Quality Control Check Report. Stage: After Finishing Stage III (Apartments)

Flat No	B-905	Other	Sl. No.	28476
Company	MPL	Project	Phase	-
Prepared by	T.Vinod Kumar	Sign	Date	29-09-21
Project Manager	Subba Reddy	Sign	Date	29-09-21
Previous stage report no.	37876	Report filed and signed by PM	☒ Yes ☐ No	
Checked By MD on	MD Sign	For filling	☐ Yes ☐ No

MAYFLOWER PLATINUM

Details of Additions & Alterations

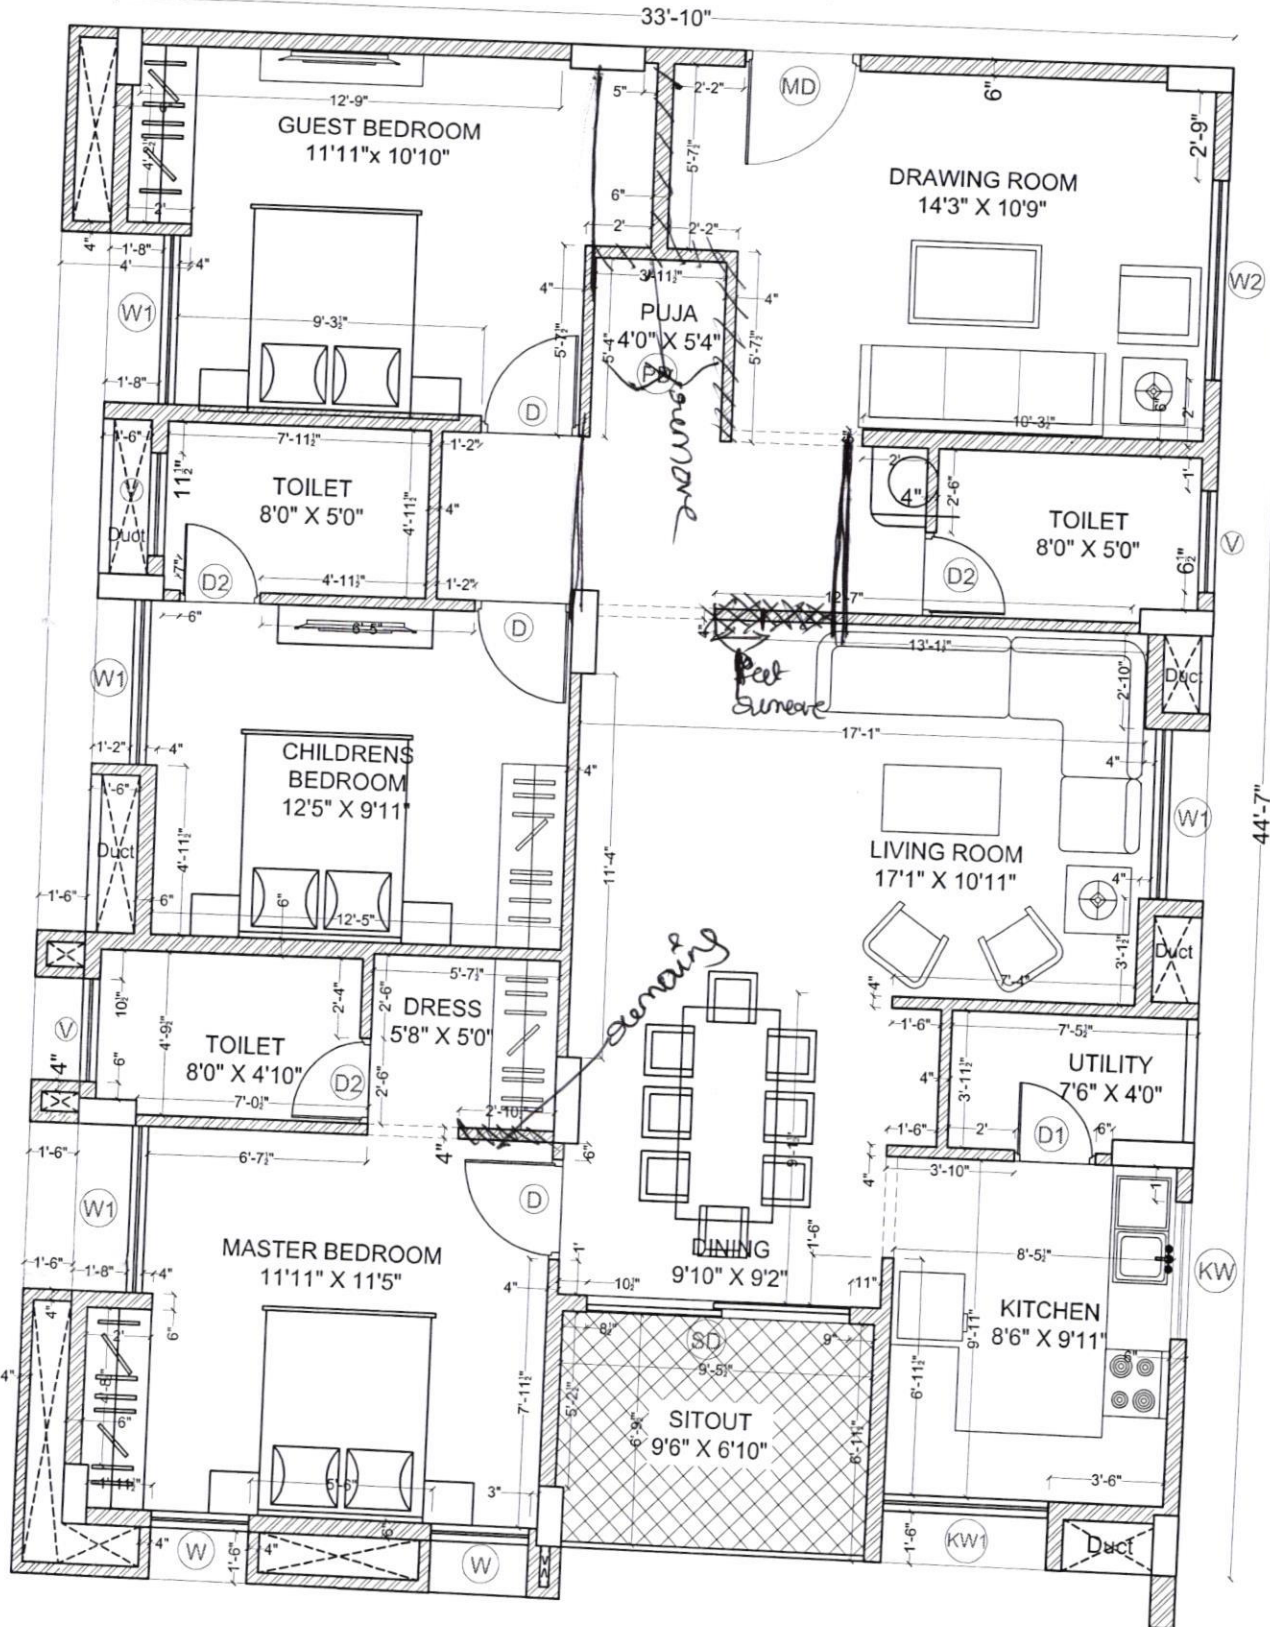
→ Same as model flat but plus 11 bedroom,
for additional cost (including kitchen)
* All rooms 2'x2' verified.
